▲ ADDENDUM #1 - REVISED 9-19-22

MAINTENANCE OF TRAFFIC - PHASE 3
STA. 1085+00 TO STA. 1090+00

POR-43-18.65

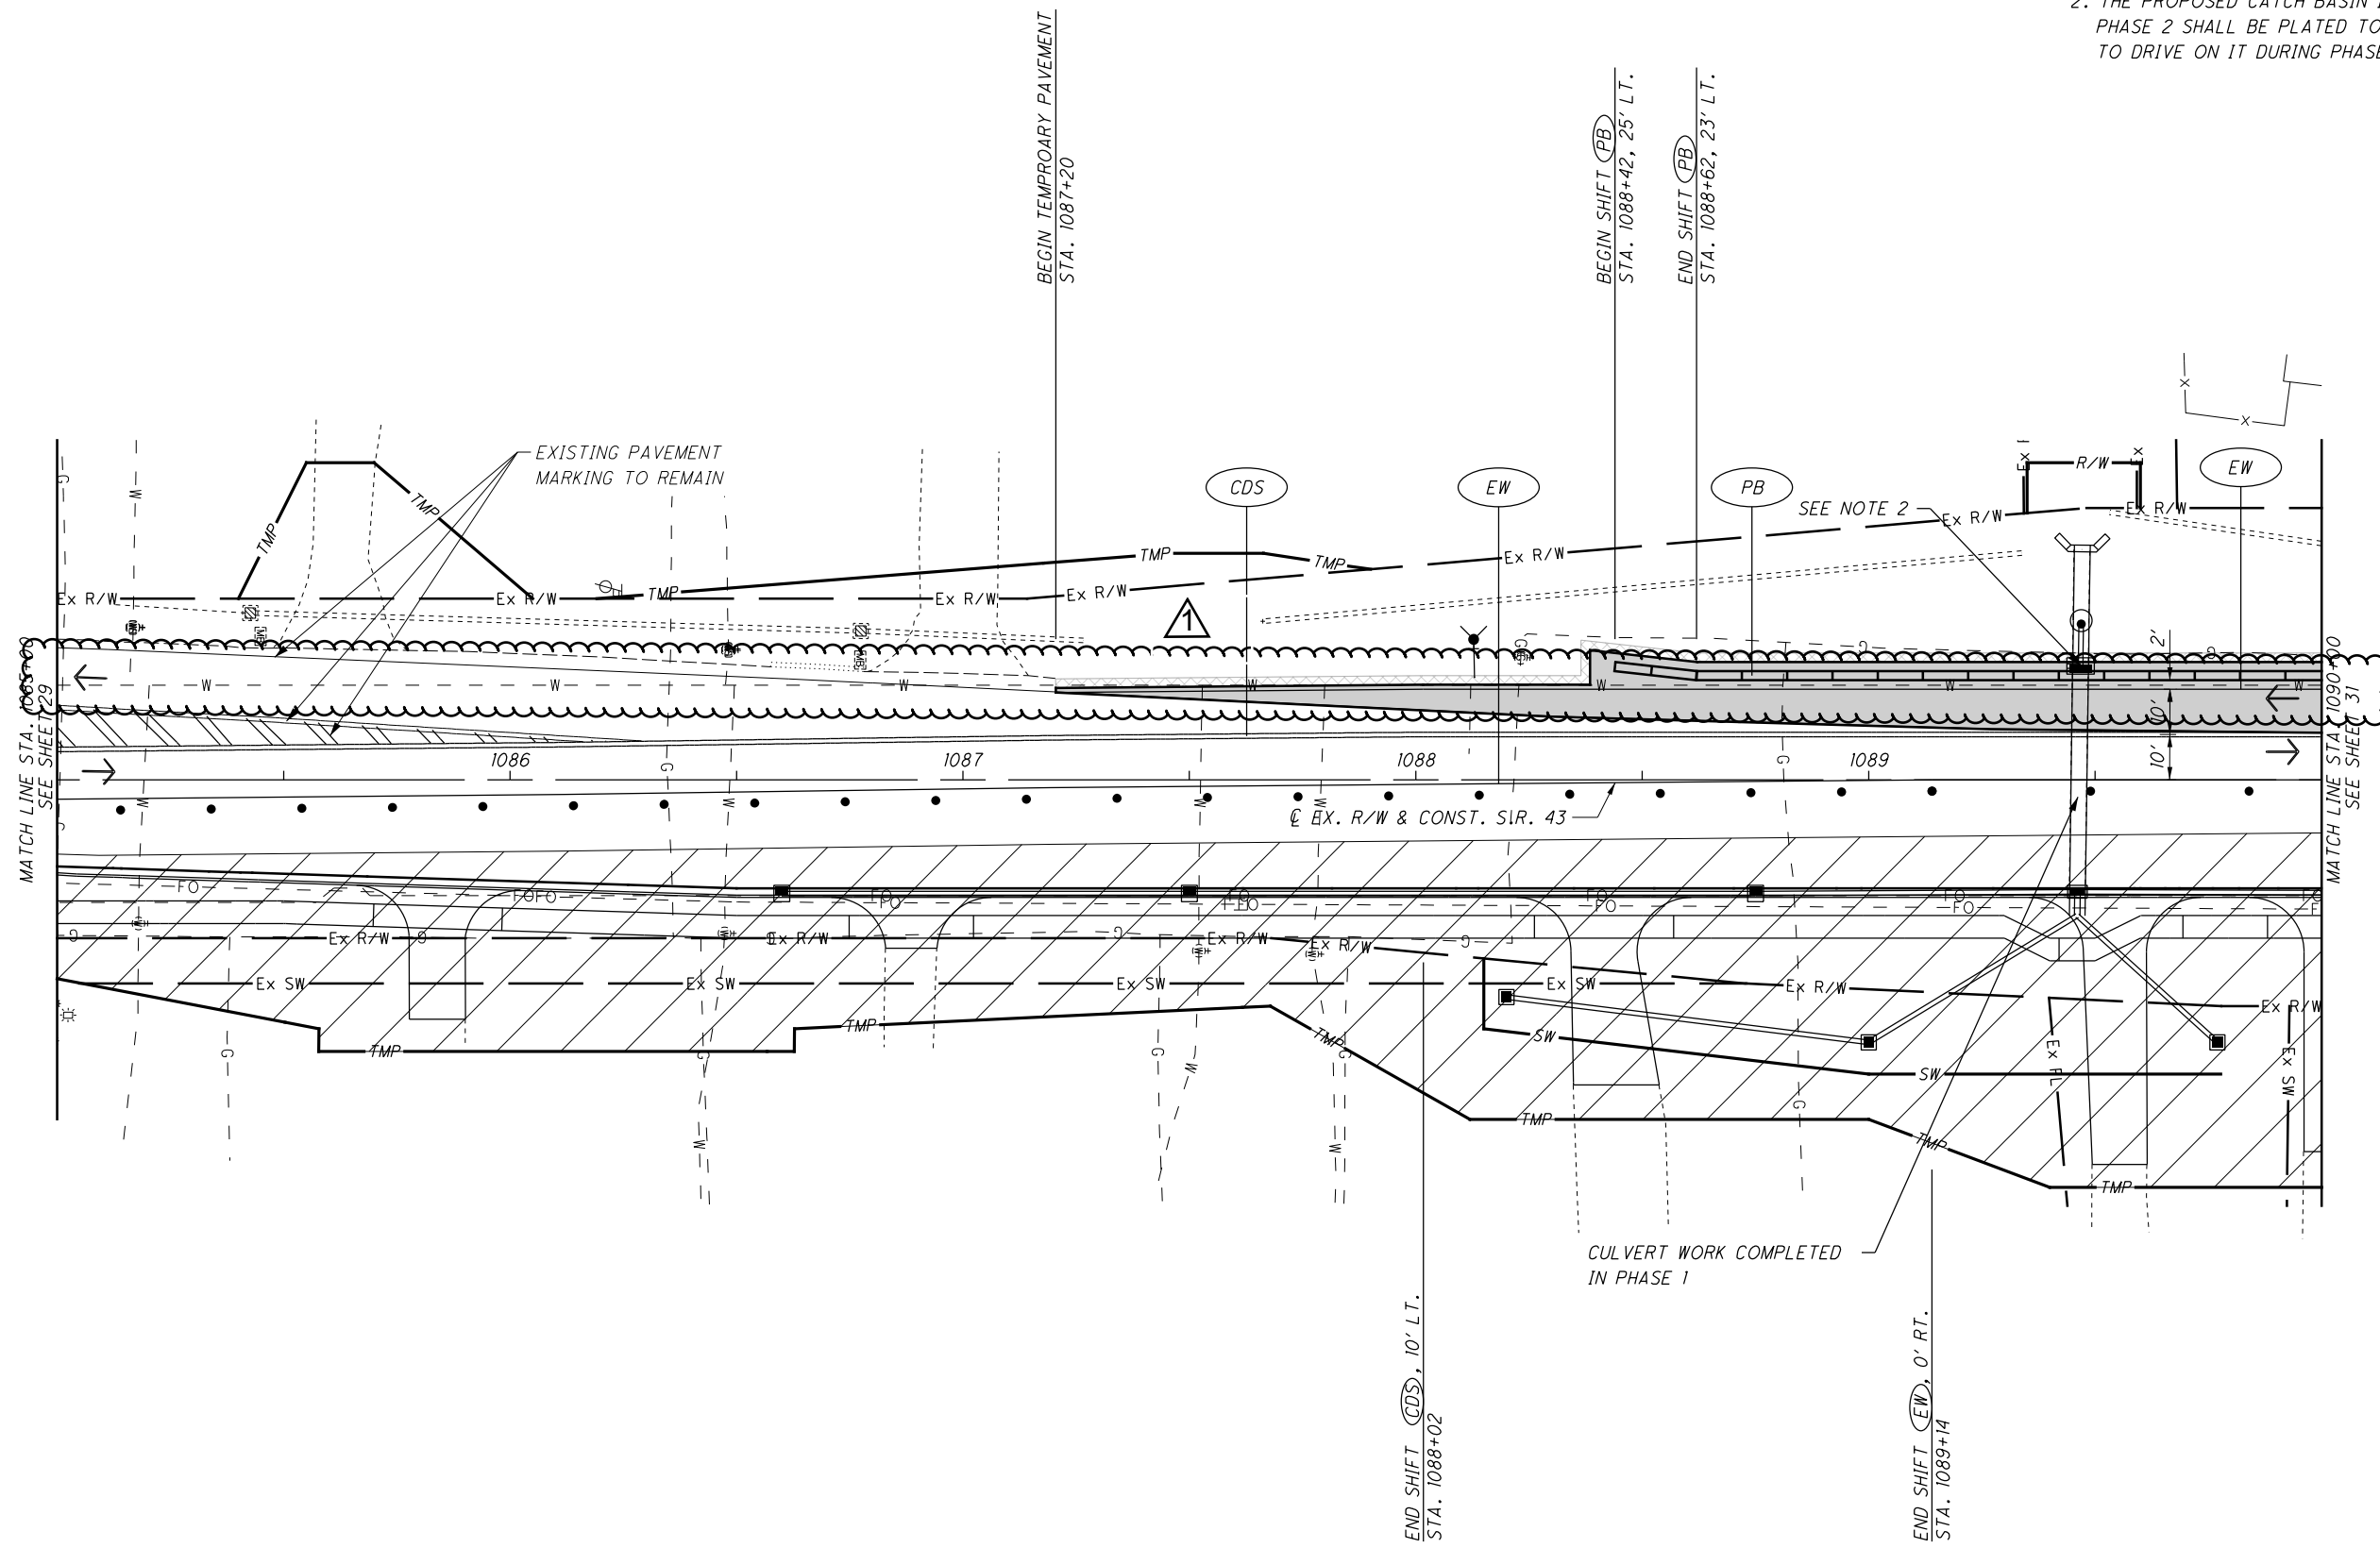
- NOTES:
1. THE CONTRACTOR SHALL COVER CONFLICTING SIGNING AND COVER OR REMOVE CONFLICTING PAVEMENT MARKINGS PRIOR TO CONSTRUCTION.
 2. THE PROPOSED CATCH BASIN INSTALLED IN PHASE 2 SHALL BE PLATED TO ALLOW VEHICLES TO DRIVE ON IT DURING PHASE 3.

MAINTENANCE OF TRAFFIC - PHASE 3
STA. 1090+00 TO 1095+00

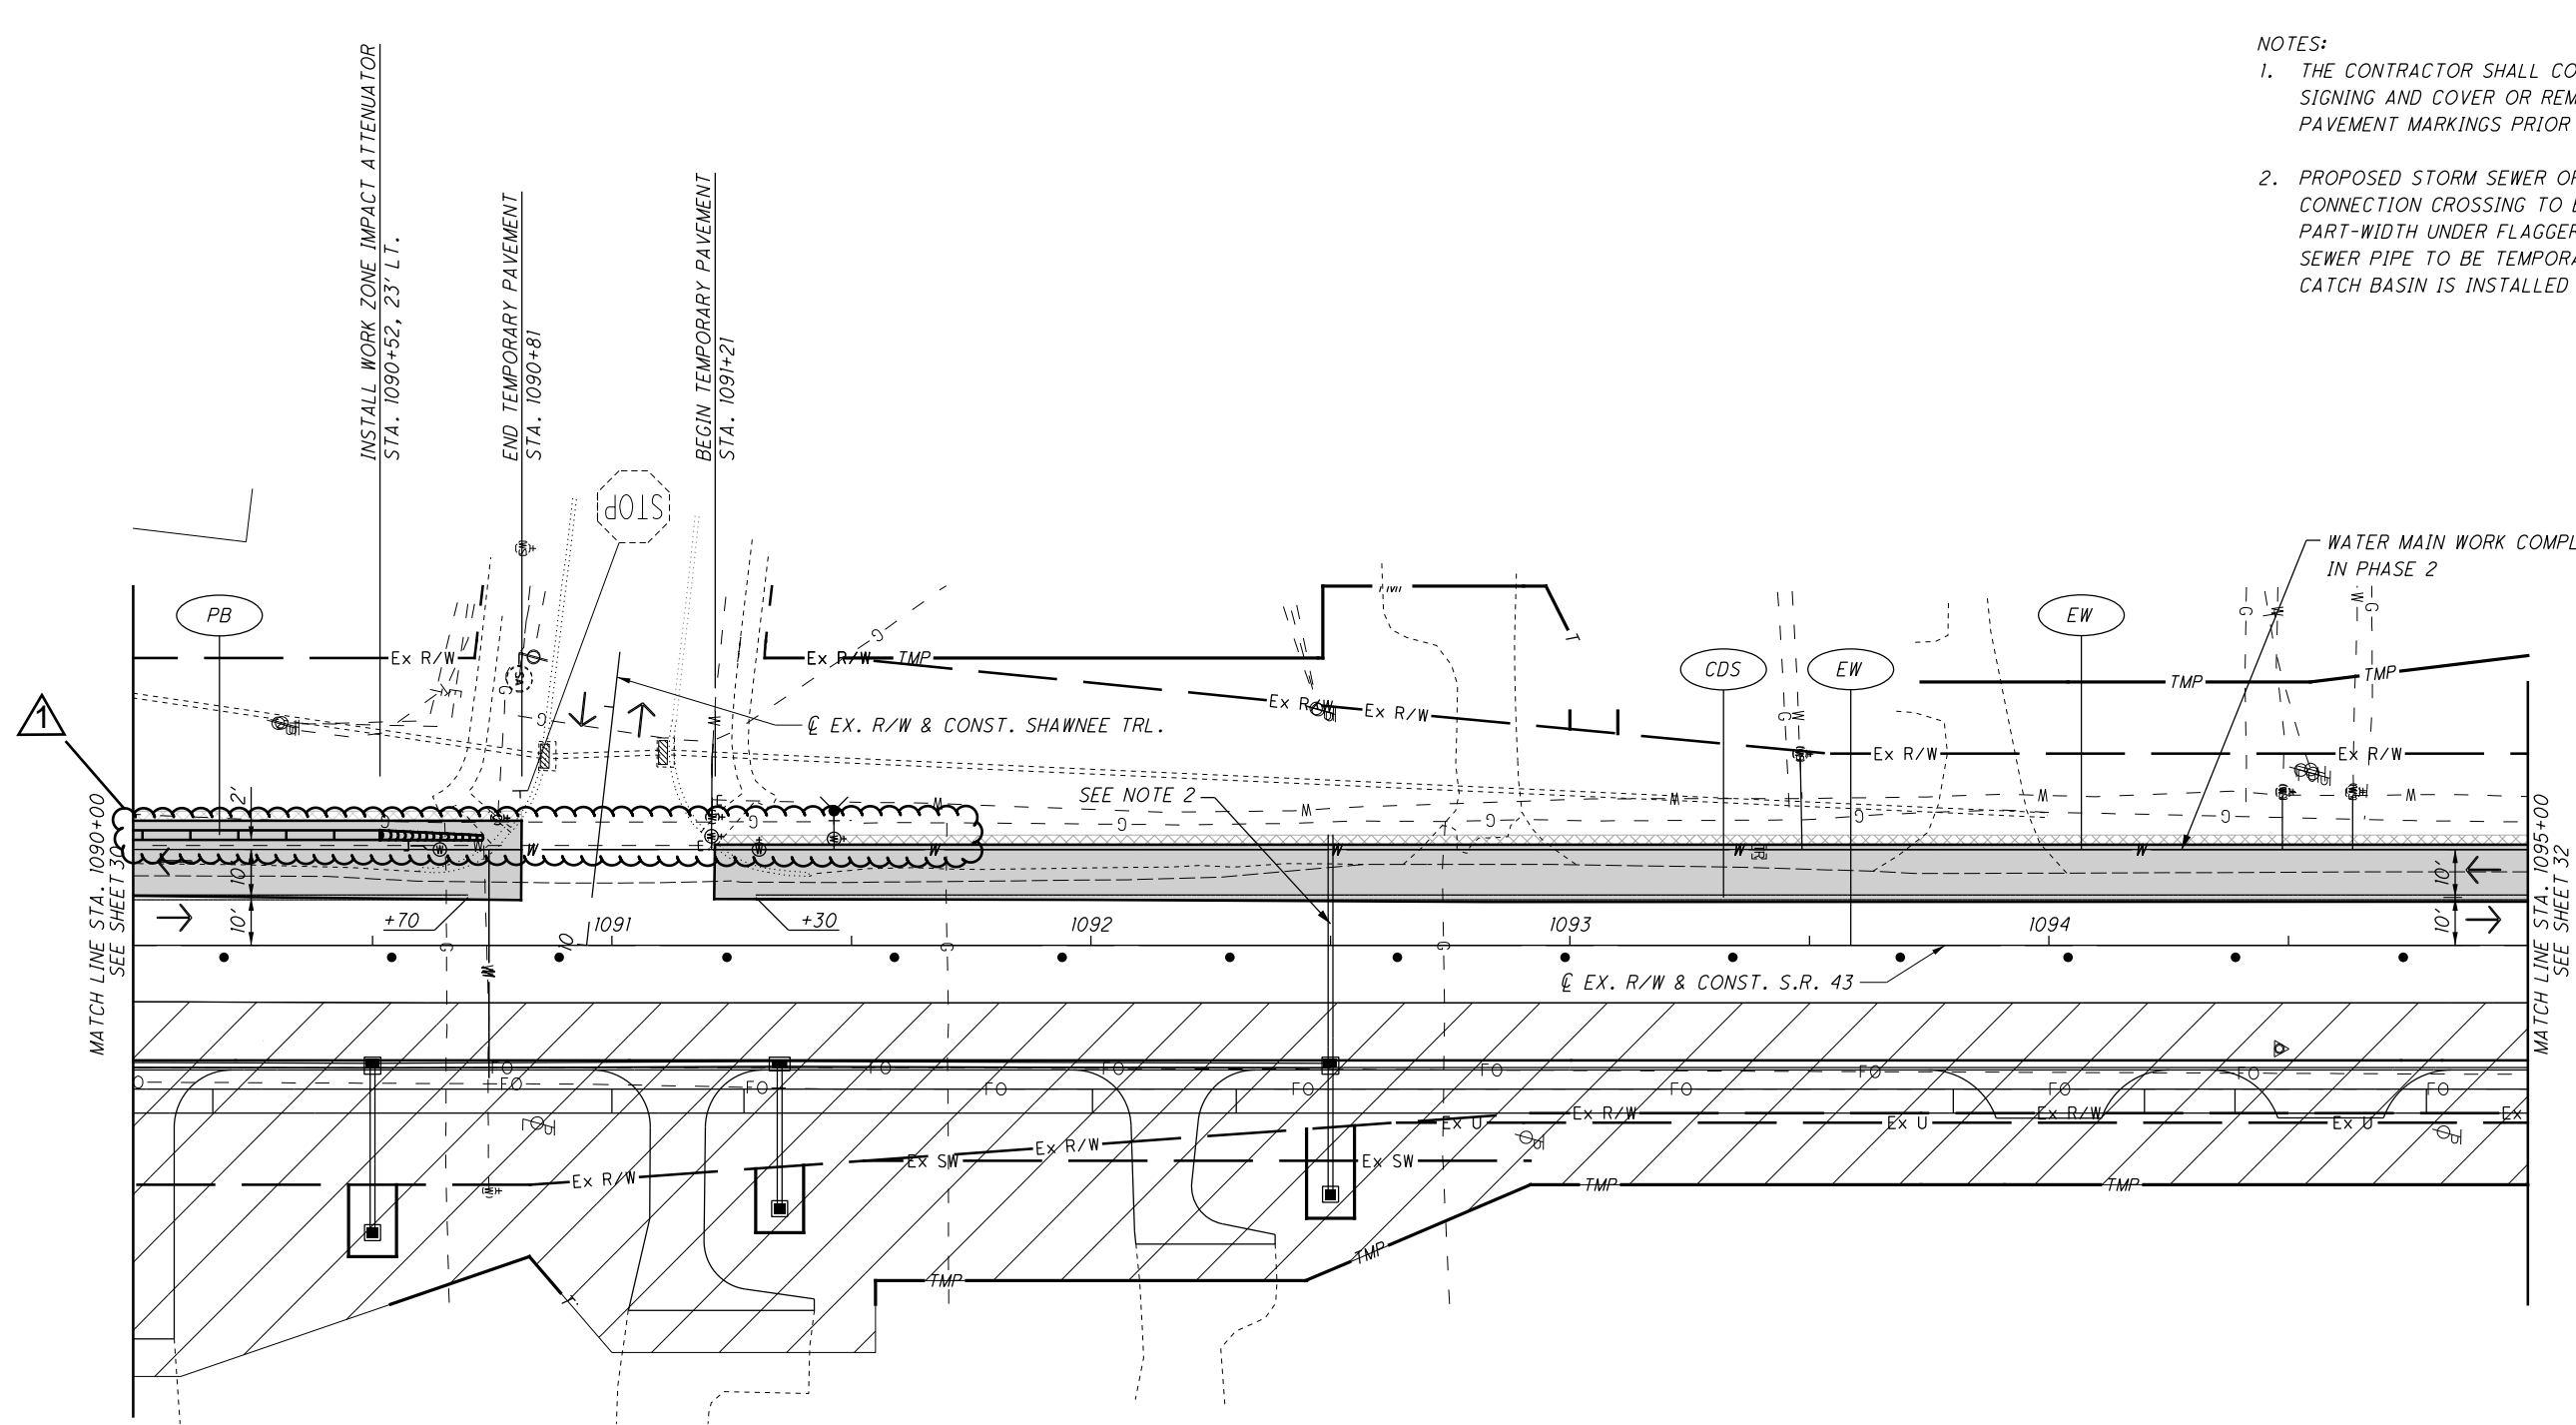
▲ ADDENDUM #1 - REVISED 9-19-22

- NOTES:
1. THE CONTRACTOR SHALL COVER CONFLICTING SIGNING AND COVER OR REMOVE CONFLICTING PAVEMENT MARKINGS PRIOR TO CONSTRUCTION.
 2. PROPOSED STORM SEWER OR WATER SERVICE CONNECTION CROSSING TO BE COMPLETED PART-WIDTH UNDER FLAGGER CONTROL. STORM SEWER PIPE TO BE TEMPORARILY PLUGGED UNTIL CATCH BASIN IS INSTALLED IN PHASE 4.

MAINTENANCE OF TRAFFIC - PHASE 4
STA. 1090+00 TO STA. 1095+00

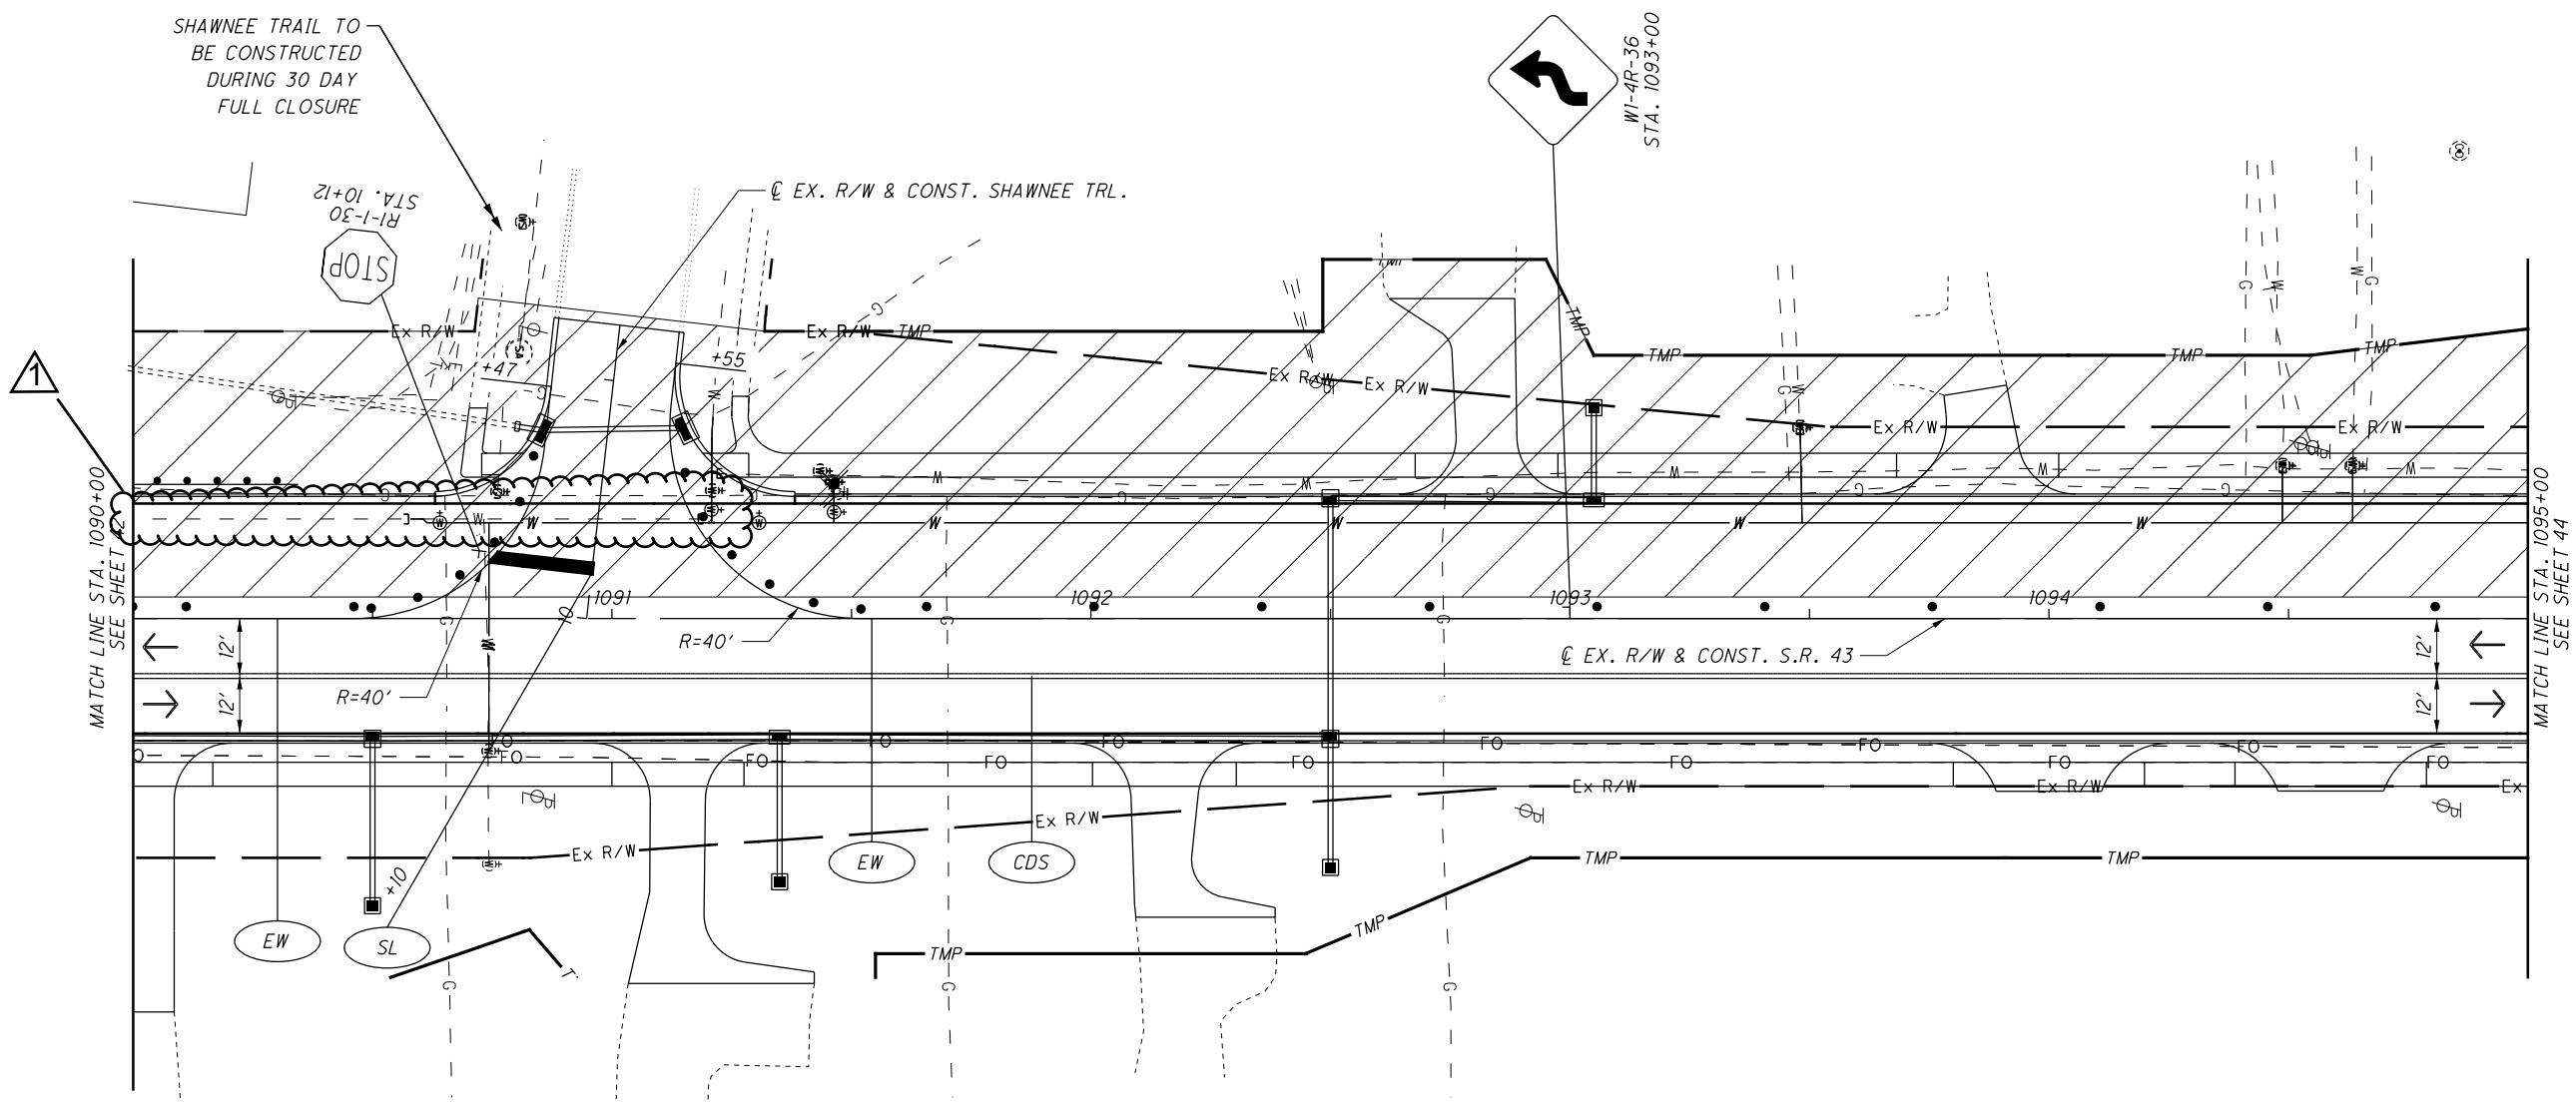
- NOTES:
1. THE CONTRACTOR SHALL COVER CONFLICTING SIGNING AND COVER OR REMOVE CONFLICTING PAVEMENT MARKINGS PRIOR TO CONSTRUCTION.
 2. STOP LINE AND STOP SIGN TO BE PROVIDED ON SHAWNEE RD WHEN ROAD IS NOT CLOSED. DRUMS TO BE RELOCATED TO ALLOW TRAFFIC TO ENTER AND EXIT ROAD.

ADDENDUM #1 - REVISED 9-19-22
